RE: Juan Tabo Library, 3407 Juan Tabo Blvd., NE Grading and Drainage Plan Engineer's Stamp Date 3-18-2015 (File: G21-D020)

Jeanne Wolfenbarger, P.E. Senior Engineer, Planning Dept. **Development Review Services**

TITLE:	GRADI	NG F	PLAN
	JUAN	TABO) LIBRA

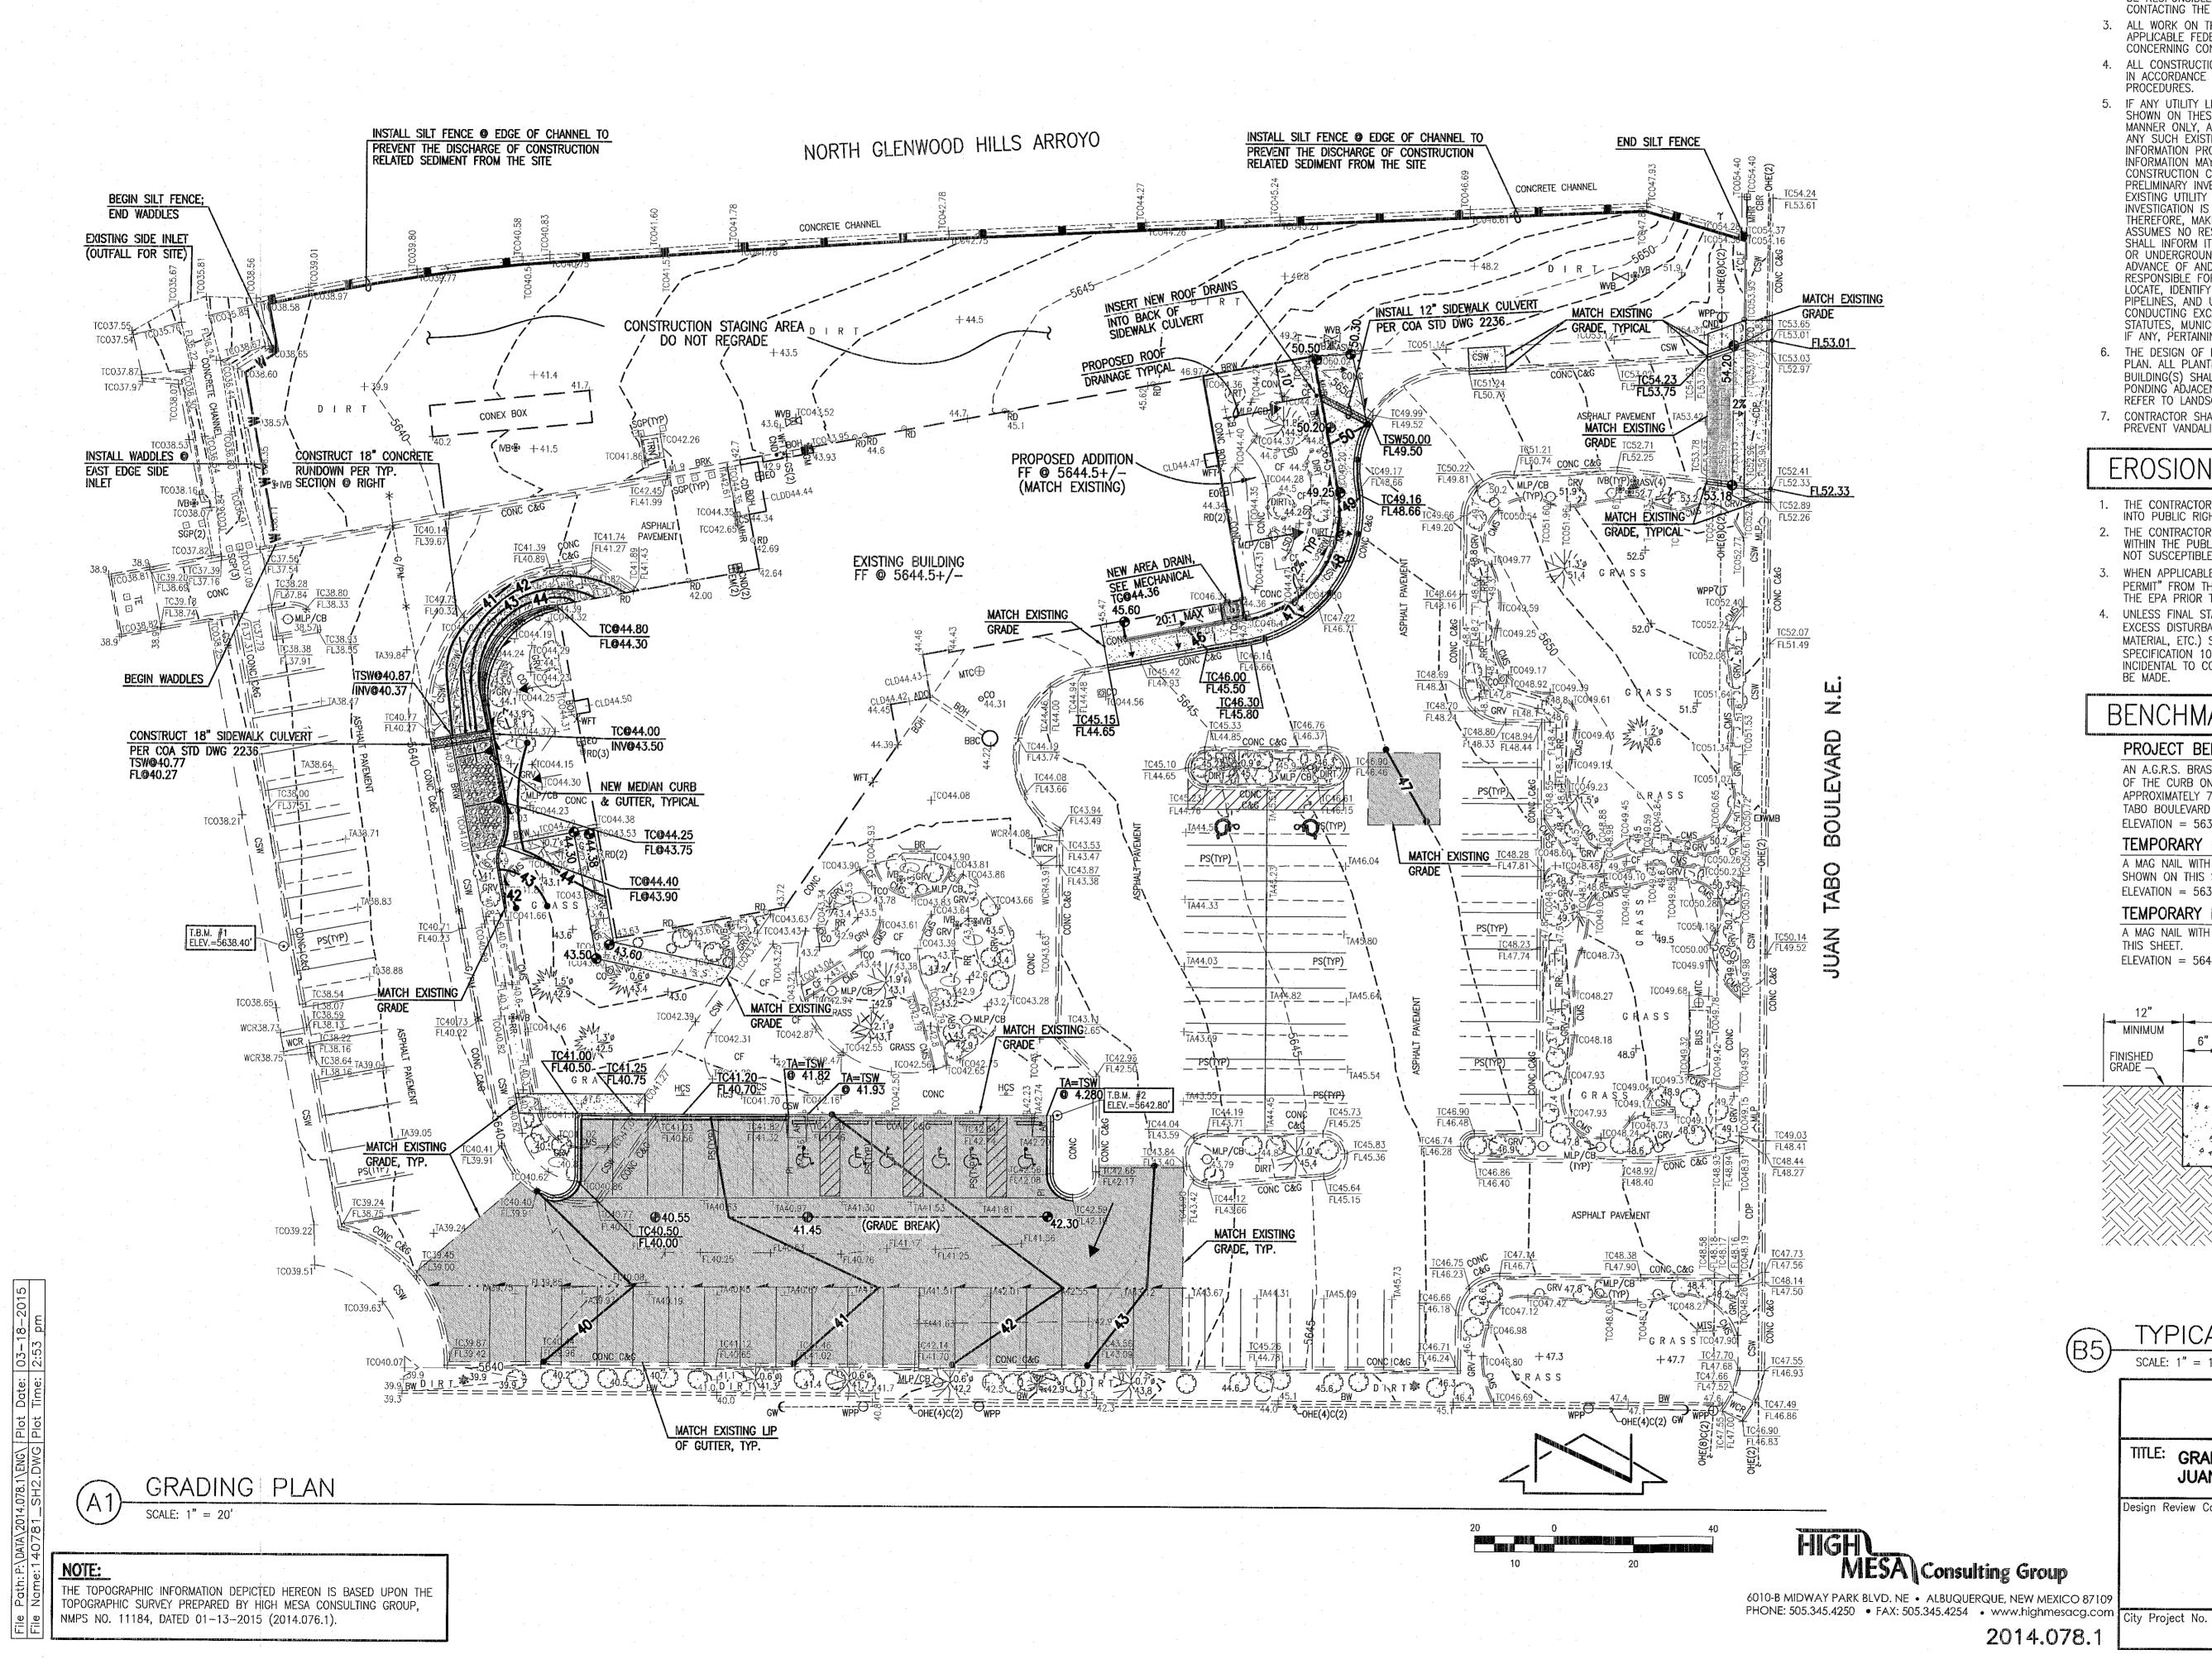
1) Label the area of the new building addition on the plan which should equal the added impervious area to the site. As a result of the added impervious area, address first flush management as required per the COA Drainage Ordinance which is defined as 0.34" times the impervious area.

2) For the proposed slopes that appear to be steeper than 3:1 along the northwest corner of the building, provide erosion protection.

3) For the access onto Juan Tabo Blvd., there is an elevation of 54.20 on the north side of the access that appears as though it should be labeled as a top of curb elevation. Please clarify. Also indicate whether the 53.18 elevation on the south side of the access is a top of curb or flowline elevation.

4) Due to the site's direct discharge into the arroyo, obtain a letter of concurrence from AMAFCA.
